Office Action Summary

Application No.
09/776,530

Applicant(s)
Garth Hystad

STRUCTURAL SANDWICH PANEL DECK

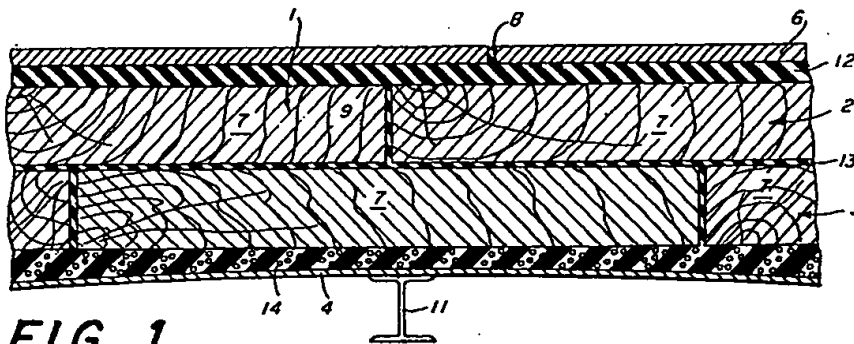
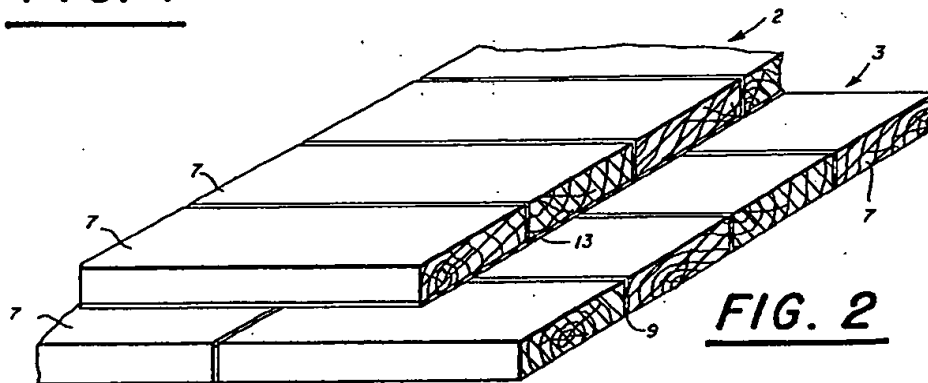
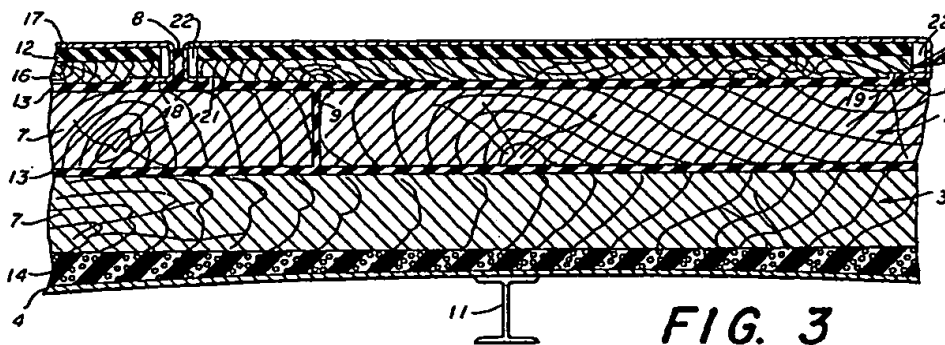
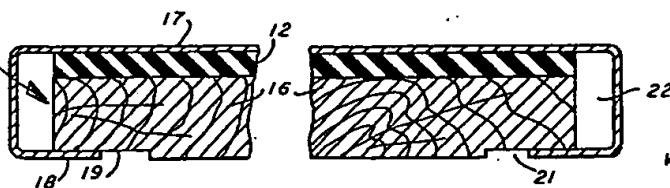
3. Claims 1 and 5 are rejected under 35 U.S.C. 103(a) as being unpatentable over US Patent #3,229,433 to MILES in view of US Patent #6,453,630 to BUHRTS et al. or US Patent #6061,991 to DAHL. MILES discloses a deck system including a floor member (16) having top, bottom and at least three sides; deck support means (11); and first metal facing means (6,17), column 3, lines 45 and 67; wherein the deck has an outer edge formed by at least one of the sidewalls (S) of the floor members (16), see the marked attachment. MILES discloses the basic claimed deck except for the floor members being formed from a wood composite material. BUHRTS et al. teaches that it is known in the art to form the floor members (15) of a decking system from a wood composite, column 1, line 51; and DAHL teaches that it is known in the art to use wood composite or synthetic wood to form the deck member, column 4, lines 65-67.. Thus, it would have been obvious to one having ordinary skill in the art to form the flooring
